B. ADDENDUM NO. 3

C. RFP #11-029

Date: November 14, 2011  
To: All Interested Parties  
From: Steve Gibson  
GRP Division Buyer

**SAN JACINTO RIVER  
AUTHORITY  
ADMINISTRATION BUILDING**

- RIPRAP SHALL BE PLACED IN ACCORDANCE WITH HCFCD SPECIFICATION SECTION 02378-RIPRAP AND GRANULAR FILL. FILL RIPRAP VOIDS AND BURY RIPRAP A MINIMUM OF 6 INCHES WITH TOPSOIL ON SIDE SLOPE AS DIRECTED BY THE ENGINEER.

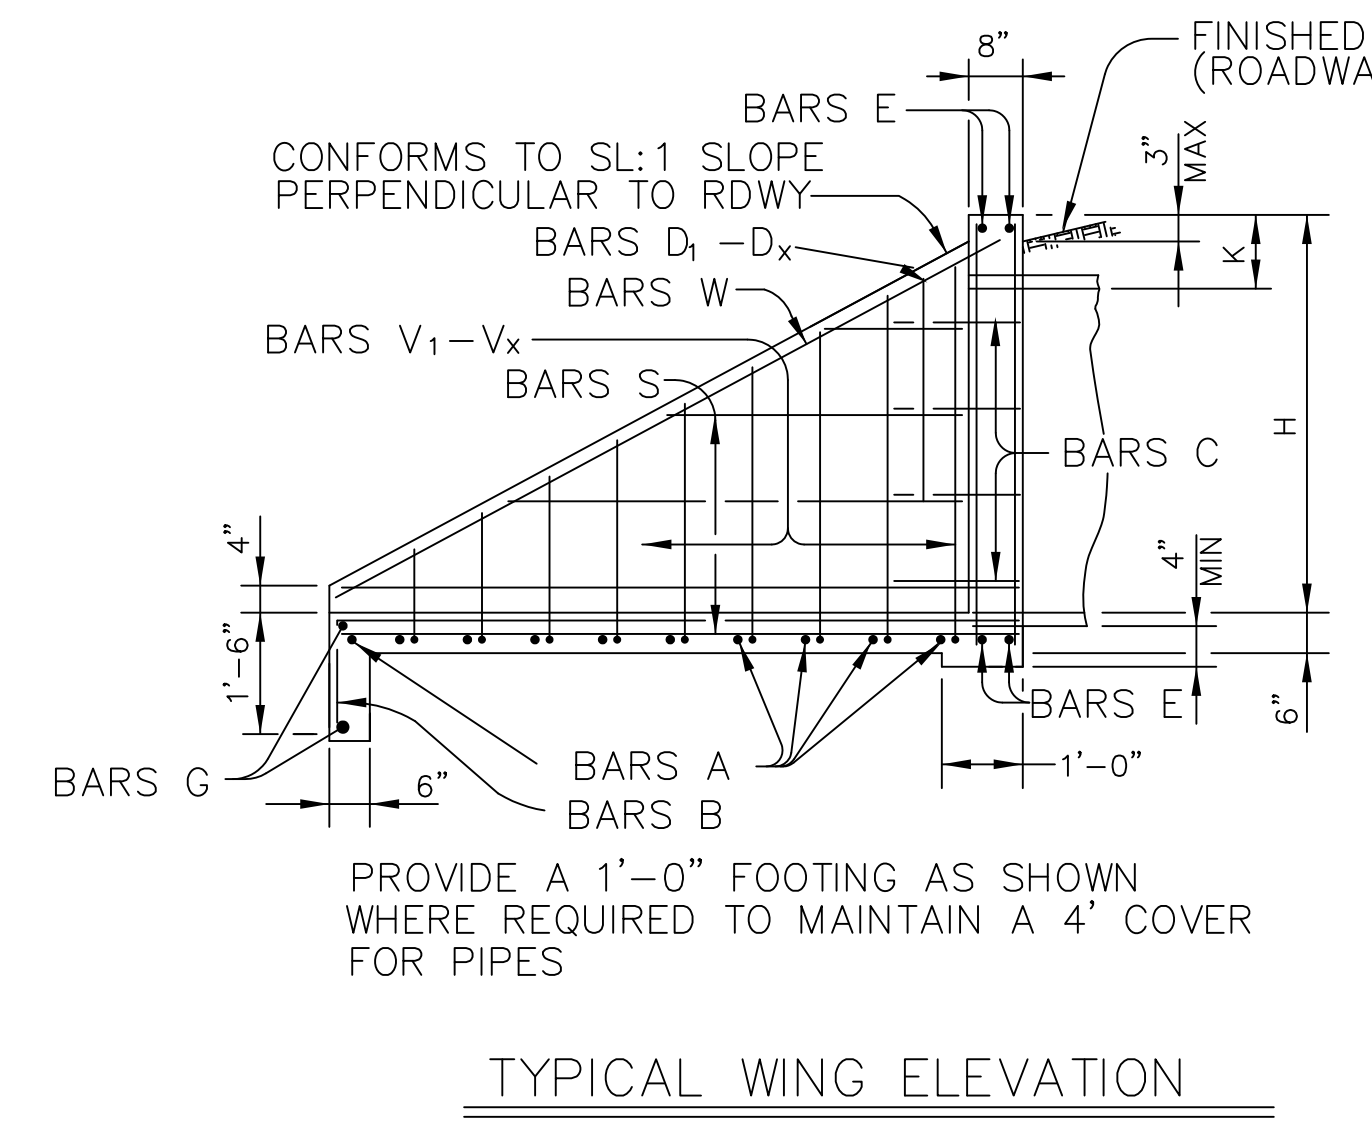
1. The revised sheet (01C-113) includes (1) the reference to the details for headwall and riprap in the callout revisions and (2) the horizontal control for the proposed detention swale. The new sheet (01C-114) contains the construction details for the proposed concrete headwall with flared wings and for the riprap where the proposed detention swale outfalls into the existing ditch.
2. Revised electrical sheets (01E-100, 01E-102 and 01E-600) issued for incorporation of 800A, 480V, 3-phase Service #2 (construction trailer power). This includes duct bank modifications as well as a pad mounted service transformer in lieu of the pole mounted transformer bank. This item No.2 only will be considered as an ADD ALTERNATE.
